## CORRO-CONSULTA

### Memorandum

**Subject: Further Discussion of the External Corrosion  
on the Drywell Shell in the Sandbed Region.**

**Figure 1**

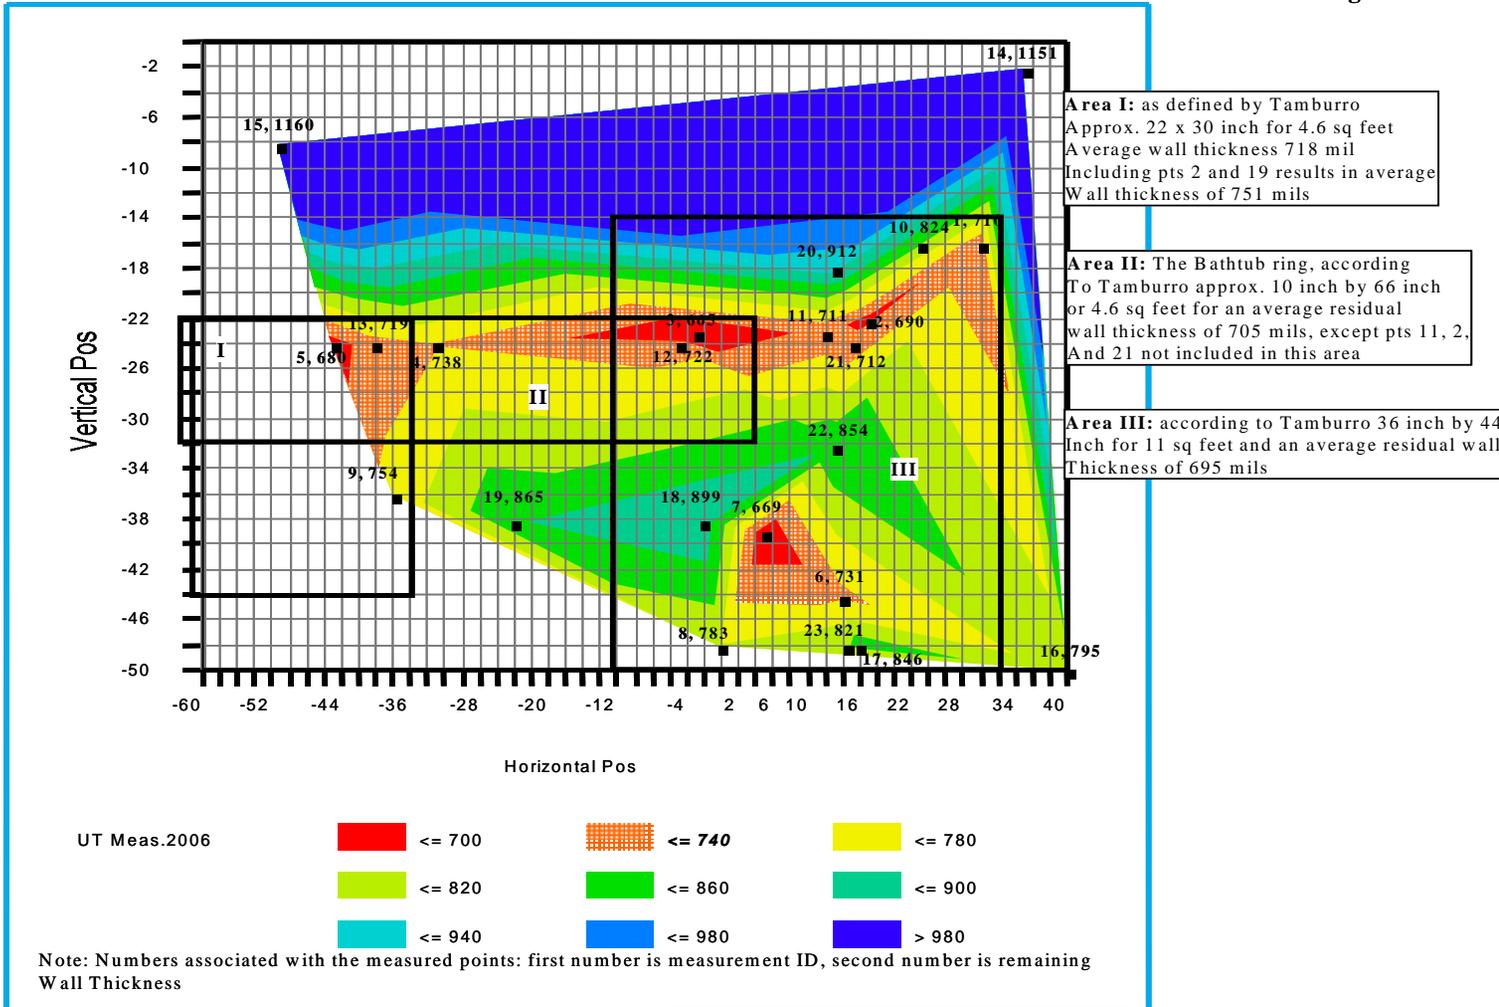
The resulting contour plot is shown in Figure 1. We have inserted the measurement ID's for each point as well as the respective remaining wall thicknesses. Additionally, we have superimposed Mr. Tamburro's evaluation, which is merely a coarse manual version of the contour plot.

Tamburro in Fig. 1-2 (Ref. 4) defines three areas as shown in Fig.1 below for individual evaluation. Thus Area I contains points 5, 9 and 13 for an “average thickness of 718 mils in an area of 22 inch by approx. 30 inch, or 4.6 sq. feet. Strangely, in Fig 1-6 of Tamburro’s work, the same area (referenced in Fig. 1-2) was narrowed and elongated to also contain points 4 and 19. The average residual thickness now was increased to 751 mils, while the estimated area was reduced to 23” by 16” or 2.6 square feet. Fig. 1 below, illustrates that the crude manual estimation by Tamburro is a coarse approximation to the surfaces generated by contouring. The advantage of using the computer is that the manual method is vulnerable to observer bias and does not provide an objective test of whether the results meet the local area acceptance criterion.

Next, Tamburro defines in Fig. 1-2 an area, which he dubs the “Bathtub Ring”. Curiously, he does not include points 11, 2, and 21 in this area even though they are clearly part of the bathtub ring (see Fig. 1 below), but includes these points in another area, which we identified as area III in Fig. 1 below. But when this area (Area III in our Fig. 1) is discussed by Tamburro in his Fig 3-1 (page 30 Ref. 4) he is not consistent in the dimensions. Nevertheless, he identifies this area as the 736 mil boundary and inserts in the same graph a 636 mil boundary somewhat arbitrarily in the middle. Now, Tamburro has identified an area of 14 x 18 inches in his Fig 1-3 as having an average wall thickness of 696 mils (points 7, 11 and 21) and being 1.75 sqft in area. But curiously, point 6 (clearly a companion point to 7 and certainly part of a corroded area) is left out of this exercise.

There are, however, other, more serious slights of hand in the Tamburro evaluation. In Fig 1-4 (Ref. 4 pg 31) he compares the area covered by points 2, 7, 11 and 21 to the local buckling criterion. He tells us that the area covered by these points is 7 inch by 4 inch or only 0.2 sq feet, when it can easily be seen from our Fig 1 below that the

area attributed to these points would be of the order of 18 by 14 inches or nearly 2 sq feet. Figure 1-4 is therefore incorrect. The same error is repeated in Tamburro's Fig 1-5.

And when it comes to the bathtub ring (Fig. 1-6) and an assessment of points 5, 13, and 4 he conveniently adds points 9 and 19 (see Fig. 1 below) to arrive at an average wall thickness of 751 mils. There is no obvious justification for including point 19 in the bathtub ring. Without it the average would have been 722 mils over an area of about 14 by 14 inches or 1.4 sq ft.

When all is said and done, Tamburro rearranges the data again in Fig. 1-7 and finds an area of 9 sq feet that has a residual wall thickness of 696. However, as clearly shown on Figure 1 this Fig. 1-7 is again incorrect because the area selected must actually be at least 42 inches by 36 inches to capture all the points show on Fig. 1-7, which is considerably larger than 9 square feet.

Figure 2

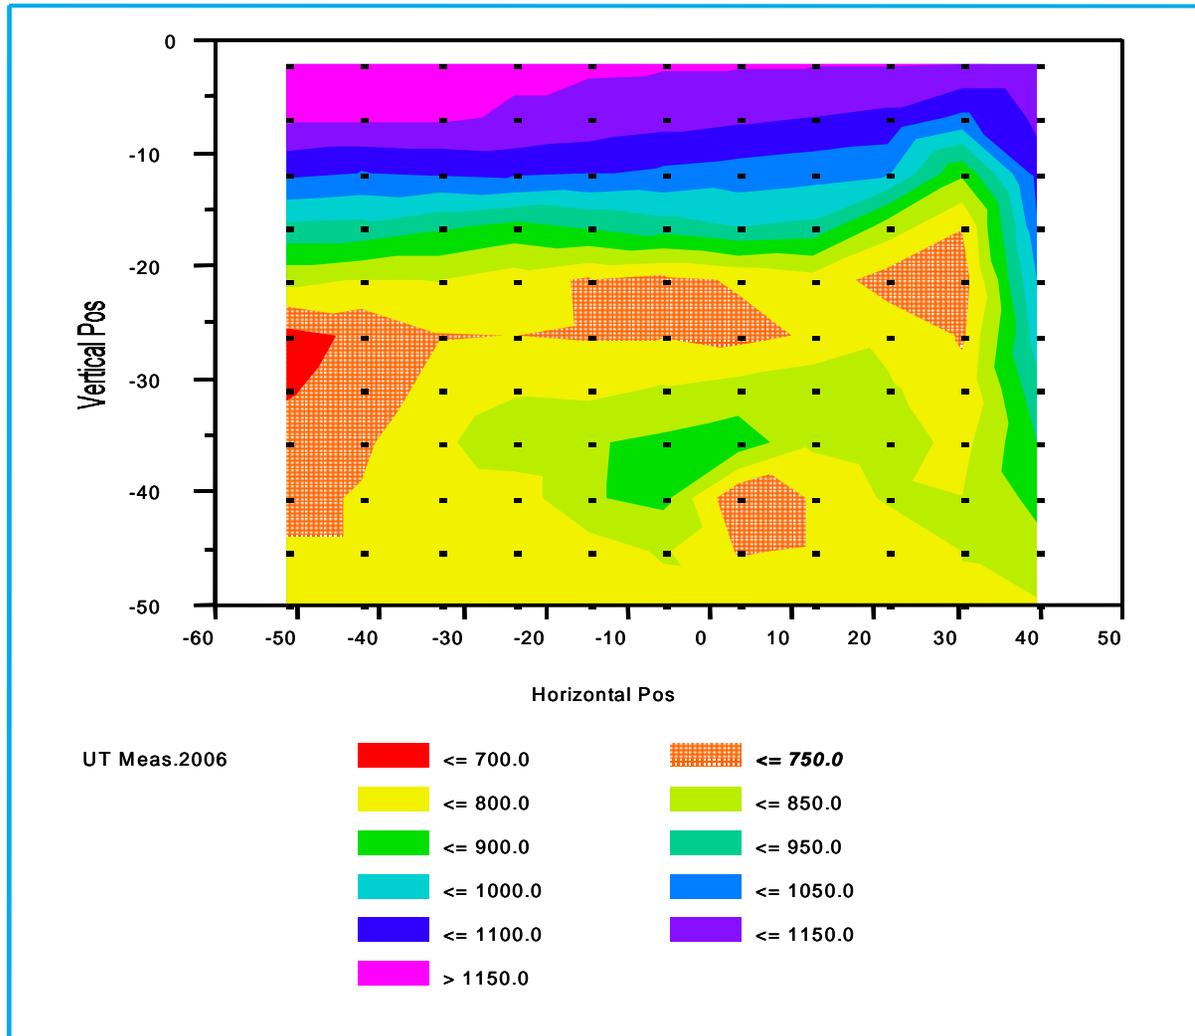
The triangulation, on the basis of which the response surfaces are generated, first generates the equations (correlation functions) used to draw the contours. These same equations can then also be used to define a grid larger than the area that had actually been covered by measurements, and to extend the contours for the purpose of predicting, in this case, the extent of corrosion one might expect outside the measured areas. This was done in Figure 2 below for Bay 1. The reason why this was done was because it was suspected that the bathtub ring might extend away from the vent line into the center of the bay. Indeed, as can be seen from Figure 2, a large area of about 15 by 20 inches might exist with a residual wall thickness of less than 750 mils and might actually extend into Bay 19. This is a prediction based on the existing data, and if verification of this prediction is outside the scope of the present intervention, it is certainly a better prediction than the assumption that corrosion stopped with the evaluation of points 5 (680 mils), and 9 (745 mils) 30 to 35 inches below the top of the sandbed.

We also see from Figures 1 and 2 that at the top of the sandbed essentially no corrosion occurred. This is in agreement with the internal grid measurements which essentially showed the same thing, **and which is in part the reason why we have concluded earlier that the internal grid measurements do not reflect the corrosion in the sand bed area and are not in anyway representative of the corrosion of the drywell liner.**

**Figure 3**

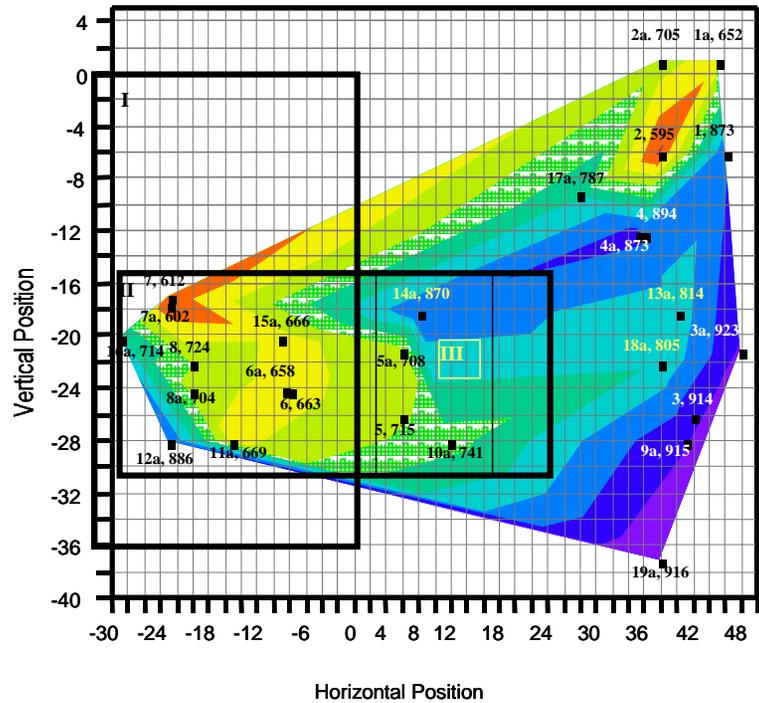
In 2006 it was reported that a number of the location identified in 1992 could not be “found” and therefore no 2006 data were reported for these locations. This was most unfortunate, because it appeared that one could not now deal with the spots of severe corrosion in the upper right hand corner of Figure 3. However, since it had been observed that on average all 2006 data were 20 mils lower than the 1992 results, the missing 2006 data were filled in with the corresponding 1992 data reduced by 20 mils. These “calculated” measurements are shown in the last column in Table 2 below in italics. Since there were duplicate measurements at the same coordinates, in some cases the coordinates of the second set of data were slightly shifted in order to include all data in the contours <sup>6)</sup>

Figure 3 below thus shows the response surface for the 2006 external UT measurements in the sandbed region. Superimposed are the three areas, I, II, and III, which Tamburro proposed in order to analyze Bay 13 corrosion in greater detail. Tamburro locates all measured points in an approximate graph of Figure 13-1 on page 63 of Ref. 4. It is noted first of all that the relative position of the individual points is distorted when compared to Fig. 3 below which is drawn with the accurate coordinates. Second, as one looks at the numbering of the points it is hard to believe that an argument could be made that the points to be measured **had not been selected at random**. Finally, we also notice that all measuring locations are indicated in Fig. 13-1, however, as we proceed to examine Tamburro’s individual areas we find that for some unexplained reasons some of the most corroded points are left out. Thus within the three areas Tamburro proposes to discuss in Fig. 13-2 we find that points 1 and 2 and 1a and 2a are missing. Clearly, the absence of these heavily corroded areas from Tamburro’s analysis grossly distort his conclusions.

**Area I:** Defined by Tamburro's Fig. 13-2 as 36 inches by 36 inches. 36 inches is Approximately the height of the sandbed.

**Area II:** Defined by Tamburro's Fig. 13-2 12 inches by 54 inches, 4.5 sq feet with an Average residual wall thickness of 710 mils

**Area III:** Defined by Tamburro Fig. 13-2 and Fig. 13-6 actually contains 4 measurements with an average residual wall thickness of 758 mils

Figure 4

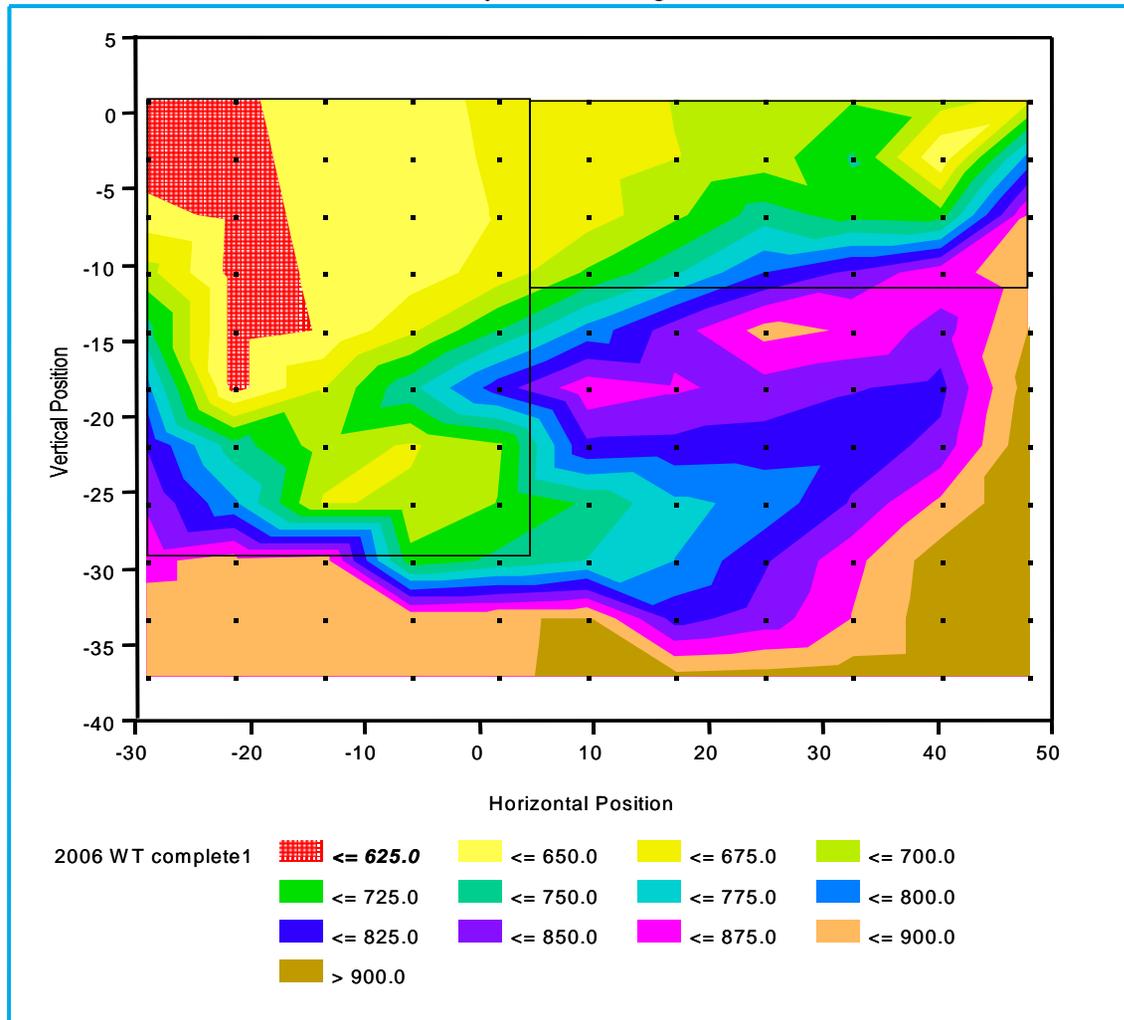
Figure 4 shows the predictive contours derived from the triangulation correlations. Note, that the areas predicted to have less the a residual wall thickness of 750 mils (dark green shading) extend all the way up to 0 on the scale of vertical coordinates, a few inches below the “internal grid measurements.” Three internal grids had been measured in this Bay (Ref. 11, Section 6, Table 6) with average residual wall thicknesses of 846 (13A). 904 (13D bottom), 1047 (13 B top) and 1142 (13 C). Thus, it is likely that the internal measurements are mostly above the angled bathtub ring, which is tapering out at 11’3” or thereabouts. **Clearly, however, none of the Internal Grid UT measurements reflects the severity of the actual corrosion in the sandbed area below 11’3” in Bay 13.**

**Predicted Response Surface for area of Bay 13**  
Contiguous Areas which are less than 725 mils about 12 sqft  
Bordered by the dark green areas.
